INDEPENDENT EXPERT ADVISORY PANEL FOR MINING

MOOLARBEN COAL COMPLEX UG4 EXTRACTION PLAN FOR LONGWALLS 409-414 (MP05_0117)

ADVICE NO: IEAPM 202508-01

Figure 11: Moolarben far-field movement database (*source: MSEC, 2024*)

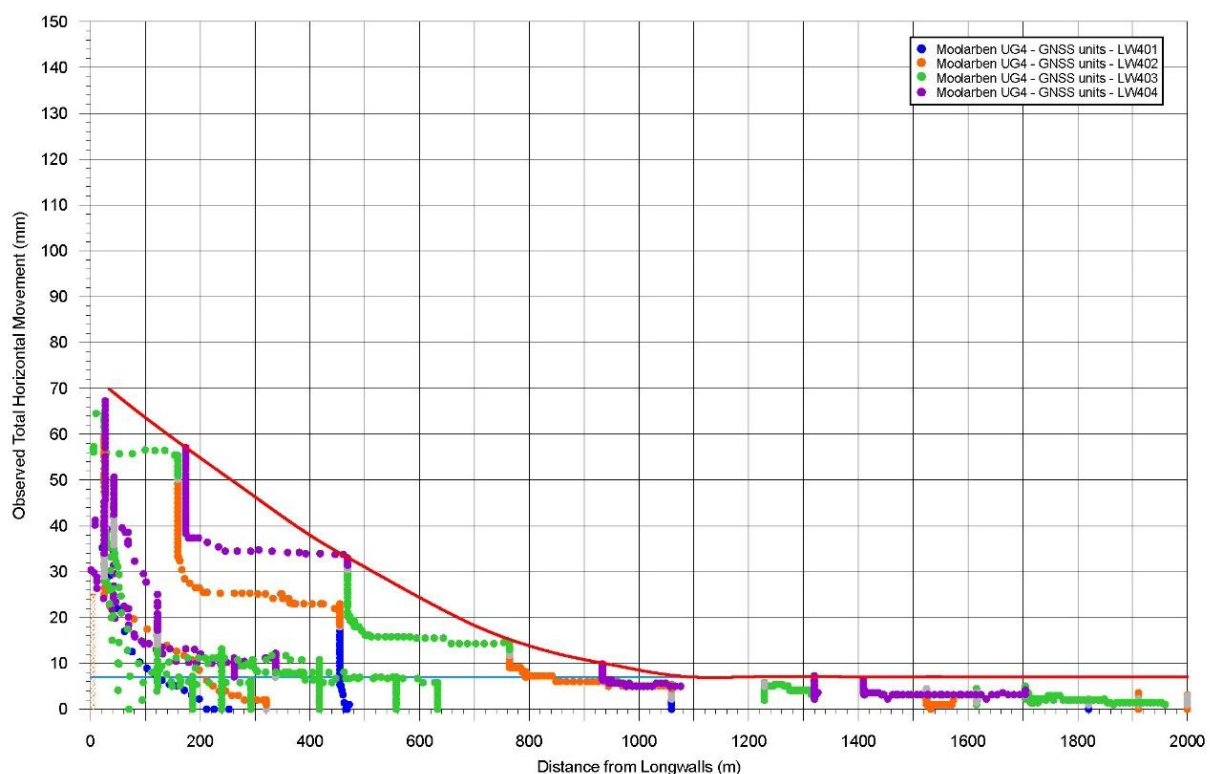
These measured results indicate a maximum value for far-field movements of 35mm at a set-back distance of 450m (corresponding to the closest Corner Gorge proximity) and approximately 21mm at 645m (the closest Drip proximity).

This database is being continually updated and the use of any parameters derived from it in the management plans should also be updated accordingly.

One of the recommendations by the Panel during discussions with Moolarben was to use the proximity of each of the initial panels to The Drip, to determine a lower level of far-field movement for the greater offset distances involved, by comparison with the predicted far-field movement indicated by the Figure 11 database. This would provide a useful incremental system of early warning for evaluating the reliability of the far-field distance prediction values and hence the overall subsidence model.

Figure 12: Location of heritage site S1MC287 (source: MSEC, 2024)

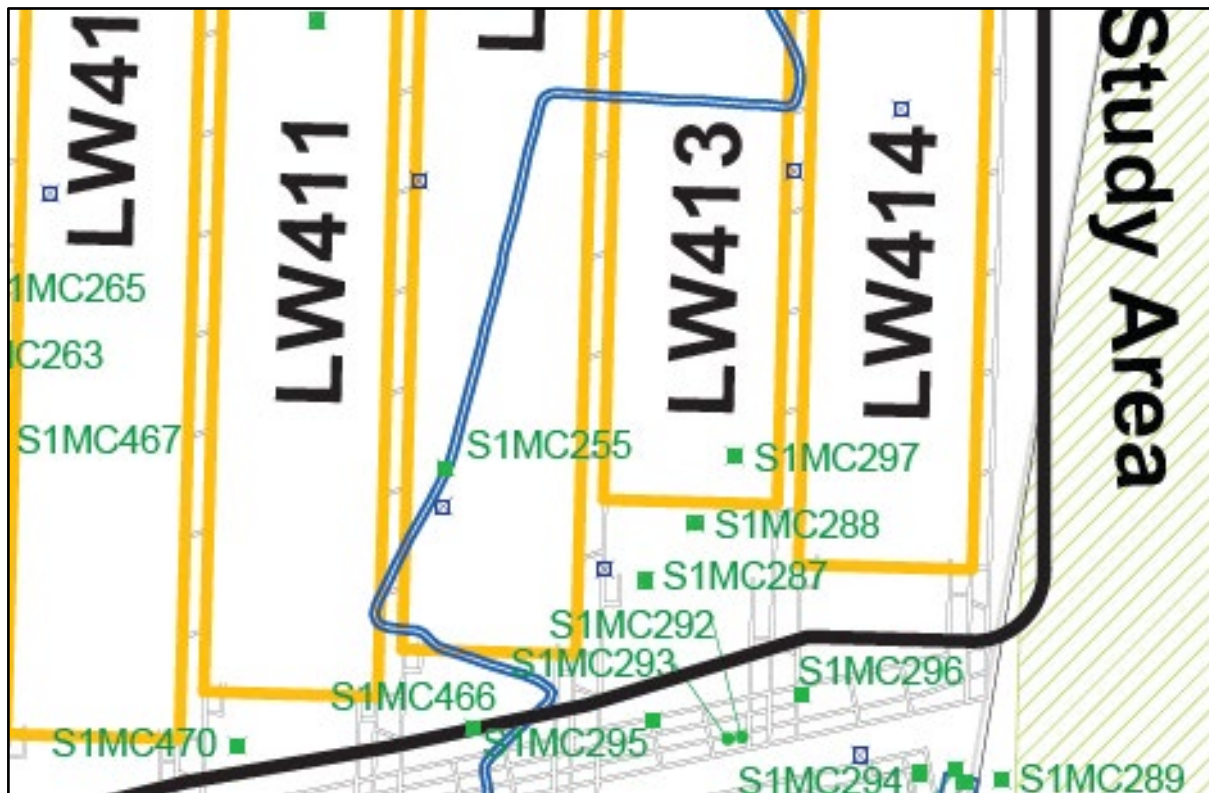
Site SM1C287 is specifically noted in the request for advice provided by the Department to the Panel. This site is located within the region of Cliff Line 3 (CL3) – beyond the southern finish line position of LW413 in a position that is also outside the Study Area boundary (as a result of LW413 being shortened to avoid damage to this cliff line), although the boundary shown on the plans does not accurately reflect this change.

The Panel is satisfied that this site should not incur any significant adverse impact, in accordance with the performance measures of low likelihood of damage. However, it is important that the monitoring program includes regular monitoring of this location – both with the approach of the adjacent LW412 and also LW413 and LW414.

Figure 13: Estimated saturated thickness of the Triassic sandstone strata as at December 2024 showing progressive dewatering above the current UG4 mined panels (Source: Figure 2.1 from AGE 2025)

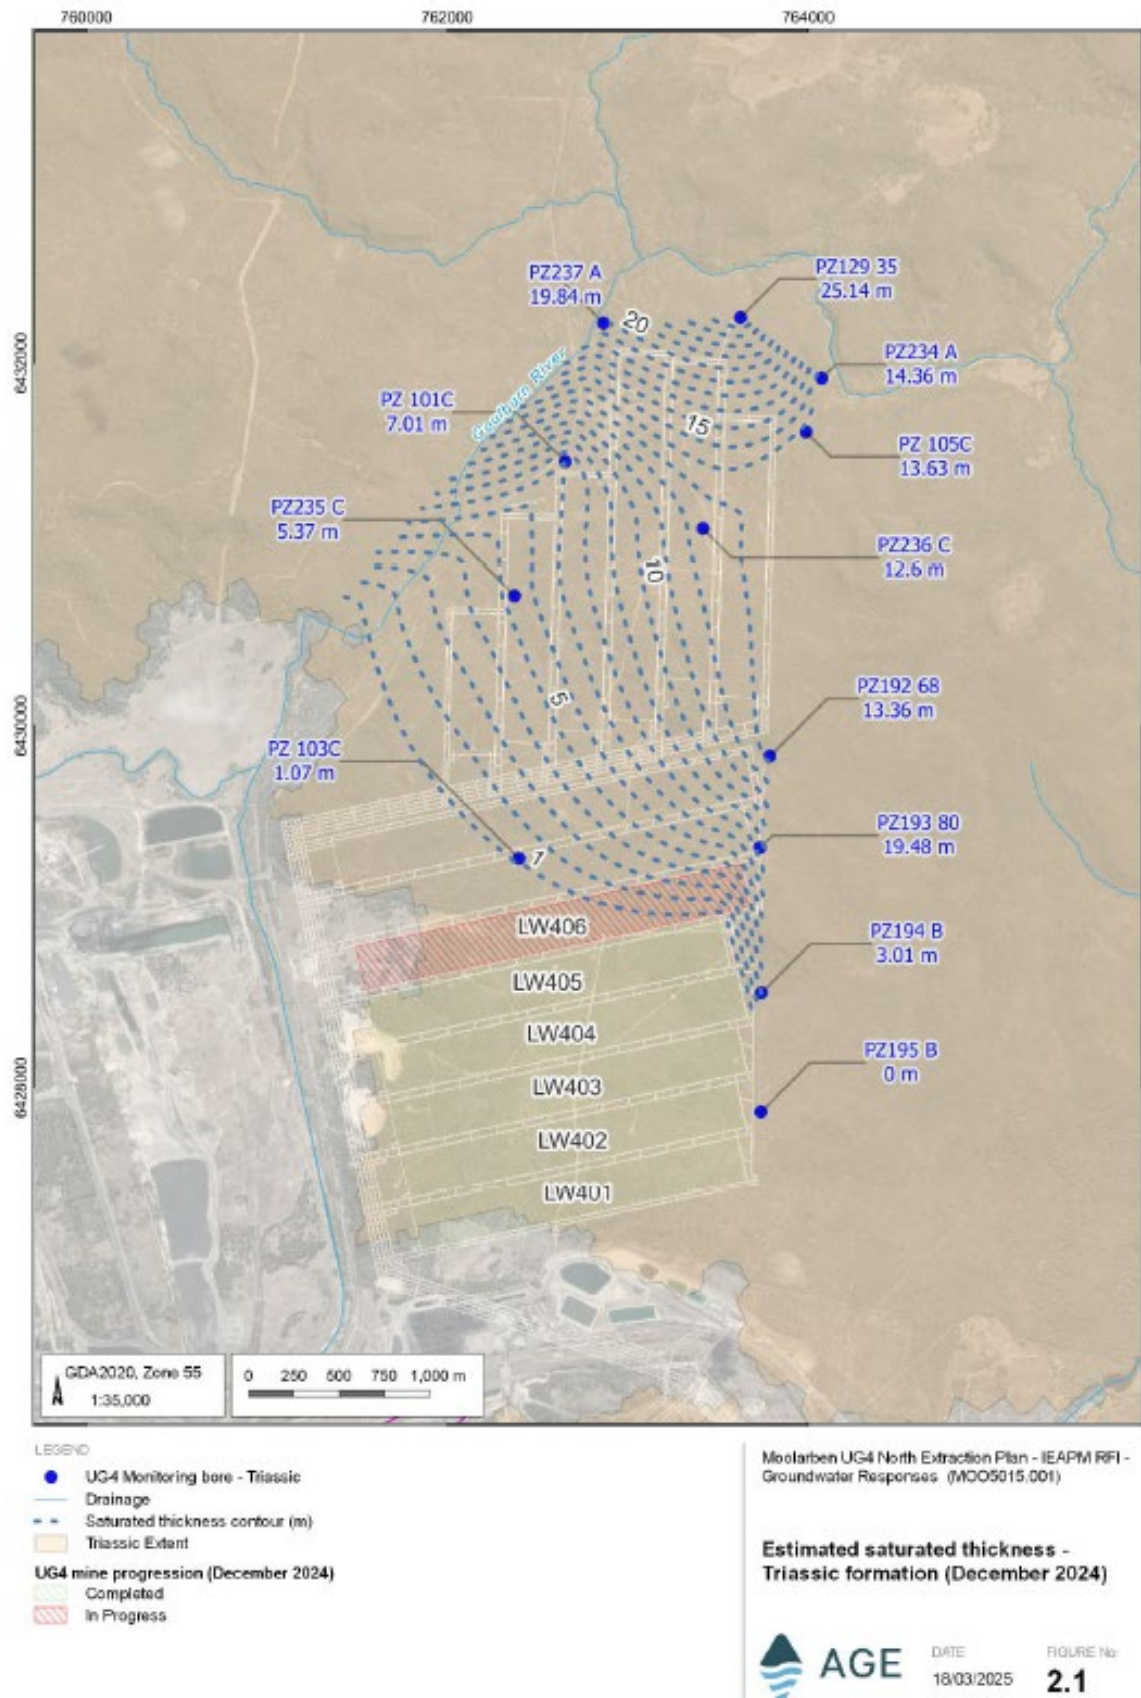
The Panel largely agrees with the updated conceptual model presented in section 4.5 of AGE (2024), with the exception that:

- There is evidence of extensive groundwater drawdown occurring within the Triassic sandstone aquifer and regional water table south of the Goulburn River.
- There is insufficient evidence that seepage at the base of The Drip is not regional water table controlled.

Figure 15: Groundwater and Cease to Flow Reduced Levels at PZ237 and SW02 (upstream of The Drip)

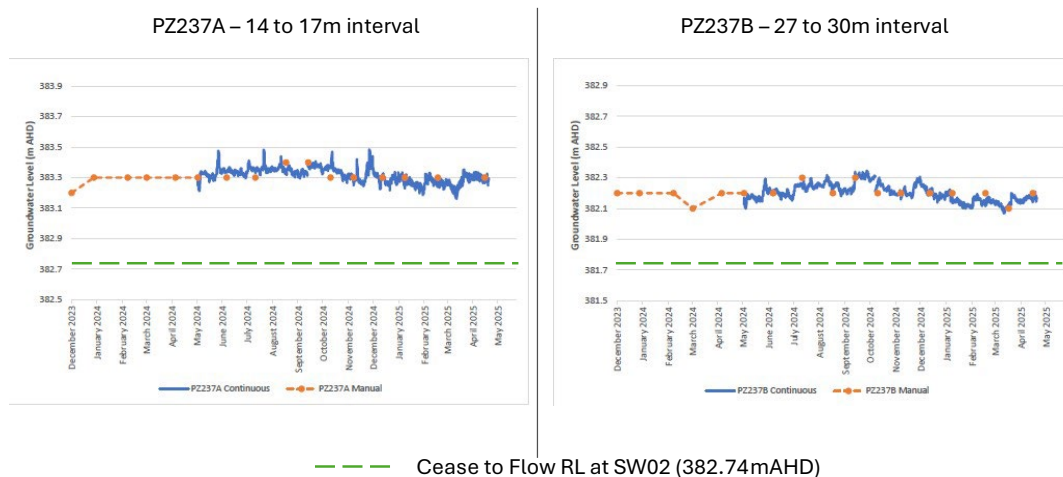
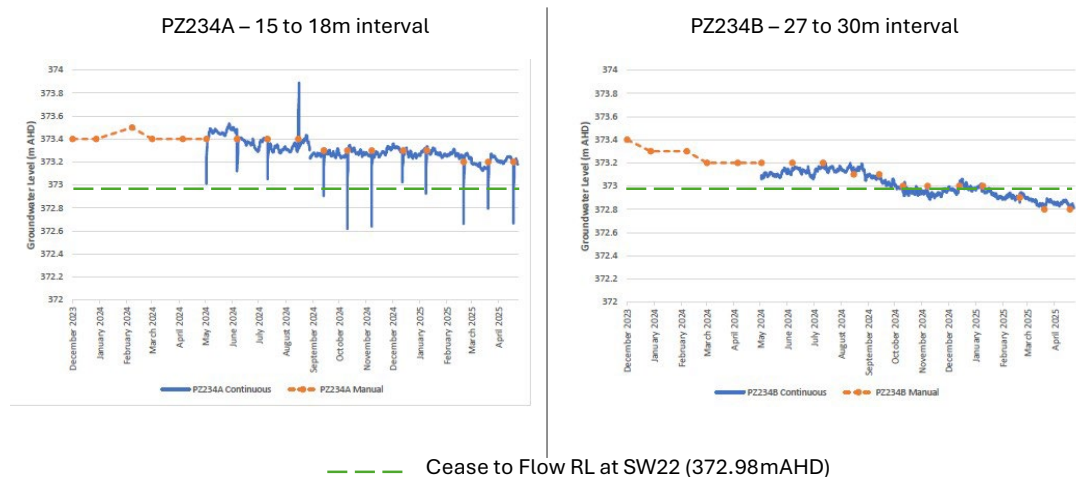
The very recent water level trend at the PZ234A site indicates that the regional water table is declining and that the slightly deeper zone in the Triassic sandstone aquifer (PZ234B) may in fact now be below river level.

The available monitoring data suggests there is reasonable connectivity between the regional water table in the Triassic sandstone and water levels in the Goulburn River. The model predictions for the baseflow contribution to the Goulburn River in 2025 across the whole model domain (for all approved mining) is of the order of 325 ML/year (Figure 5.20 in AGE 2024). This is predicted to reduce to 310 ML/year by 2036. This volume has not been segmented into the likely contribution and predicted loss between stream gauges SW2 and SW22.

Figure 18: Indicative monitoring bore locations proposed north of The Drip

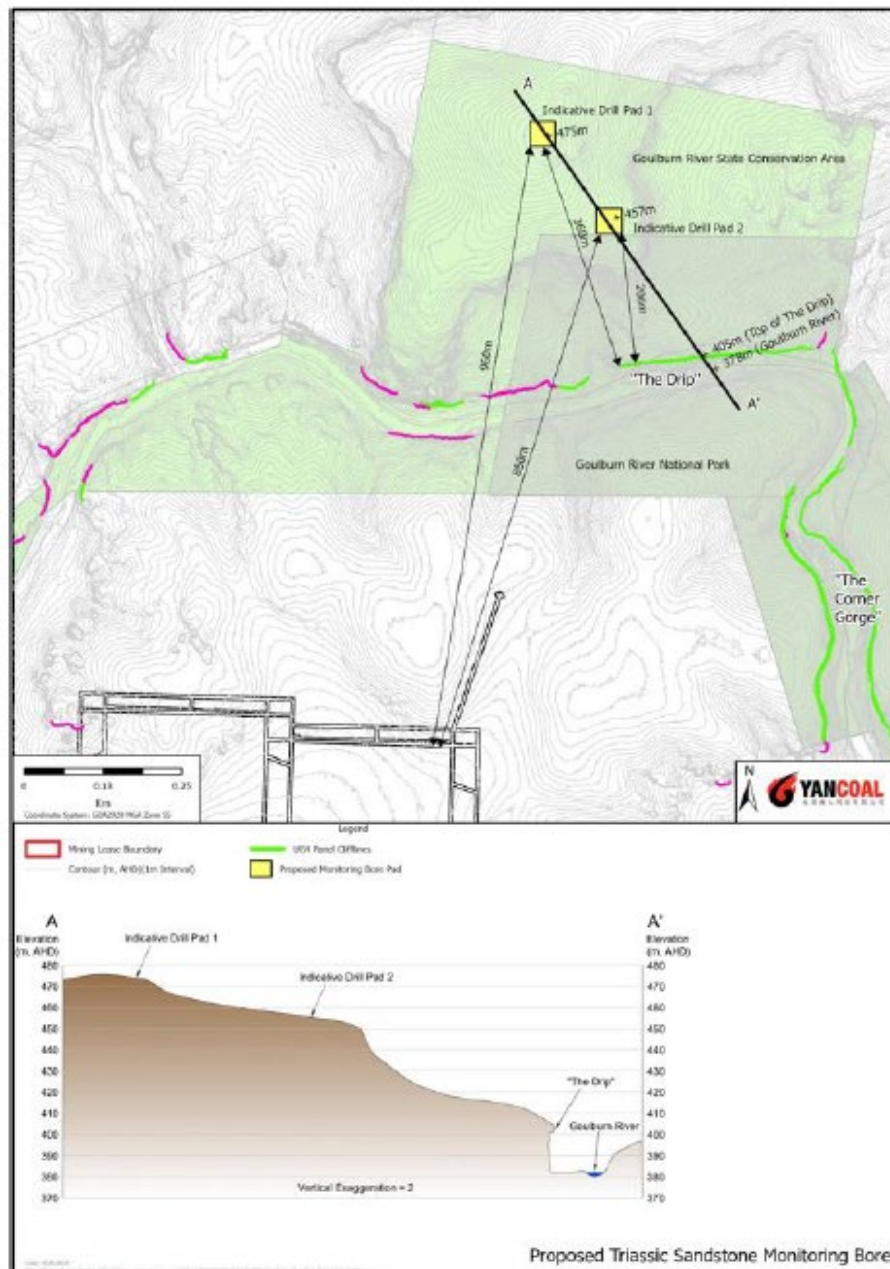
However additional groundwater monitoring is required north of the Goulburn River. MCO has committed to installing monitoring bores immediately north of The Drip to confirm the nature of the aquifer zones and to monitor water levels within the Triassic sandstone. One site will be a VWP piezometer with an unknown number of sensors, the other site is described as an ‘open hole’ standpipe. Indicative locations are shown in Figure 18 (AGE 2025). The location closest to The Drip at the slightly lower elevation is preferred for the standpipe location.

The Panel recommends that two (nested) standpipes be completed at the standpipe location rather than a single ‘open hole’ completion to prove that the first water cut is perched groundwater and that the deeper water cut at river level represents the regional water table. An ‘open hole’ completion is likely to drain perched groundwater and could have the unintended consequence of draining seepage flows that would have otherwise migrated towards The Drip. The Panel strongly recommends against an open hole completion for this monitoring site.

As a part of the development of the design and installation procedures for these sites the Panel recommends that a risk assessment is undertaken to minimise the likelihood of adverse impacts on the groundwater system and The Drip.

Figure 21: Maximum predicted cumulative drawdown in the Triassic Sandstone local to the Goulburn River in the Triassic sandstone (Lithic) until end of mining (2038) [reproduced from Figure 5.15 (AGE 2024)].

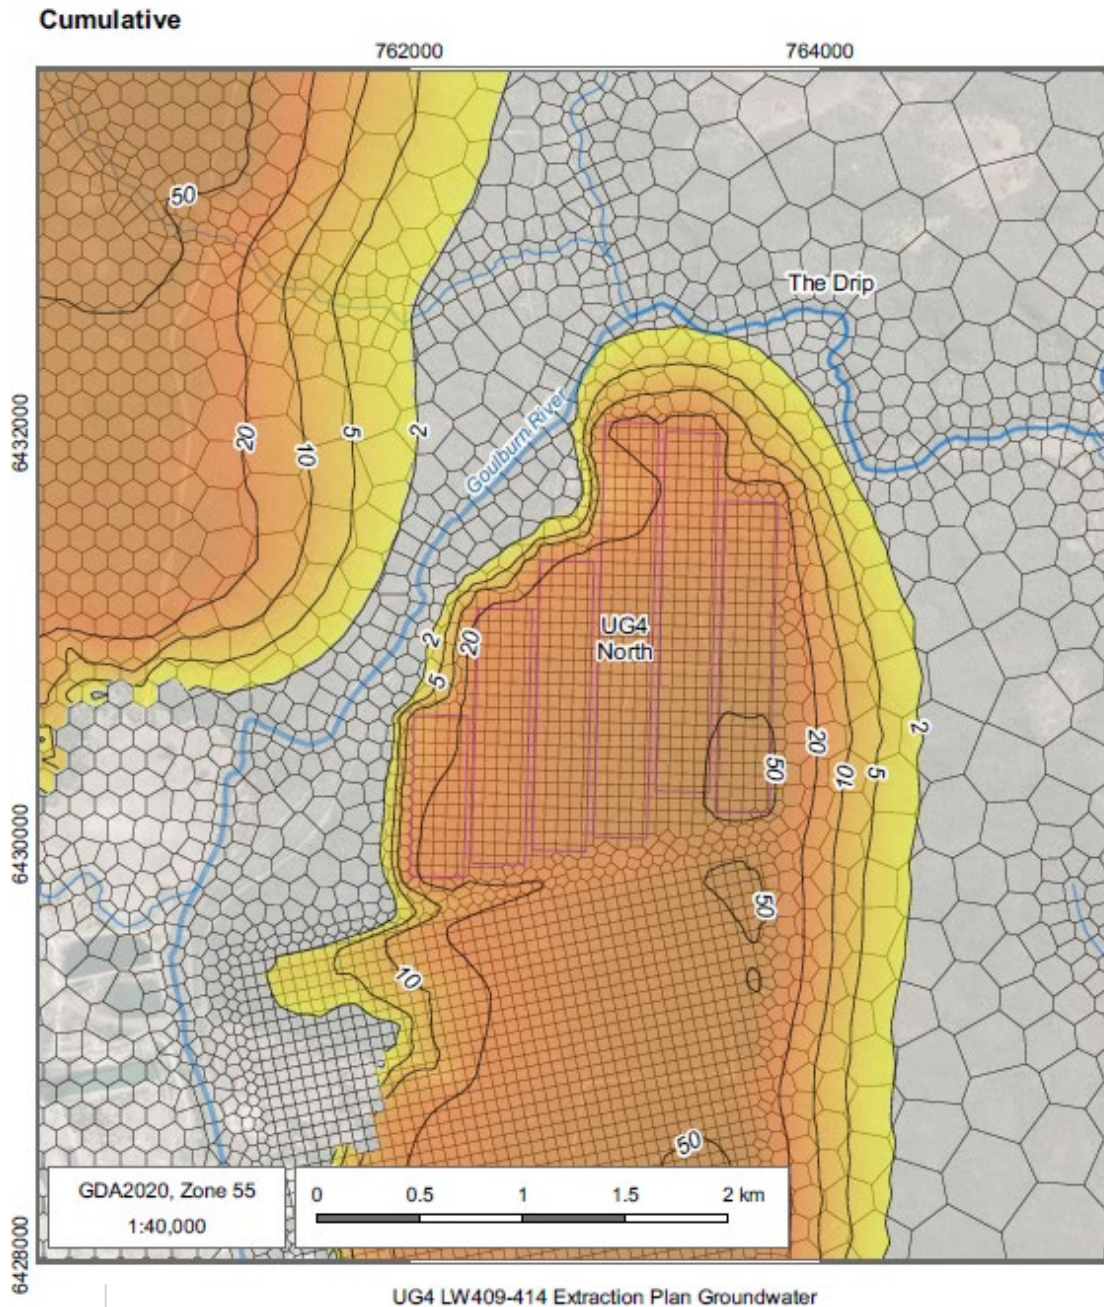
It appears from the current modelling predictions that if the drawdown beneath The Drip exceeds the current predictions, the exceedance would occur even without the planned mining of the current longwalls. This is most easily seen from Figure 5.15 of AGE (2024), reproduced in part in Figure 21 below, which shows the encroachment of drawdowns from the UCC to the west as well as encroachment of drawdowns from the south on the Triassic sandstone beneath the Goulburn River.
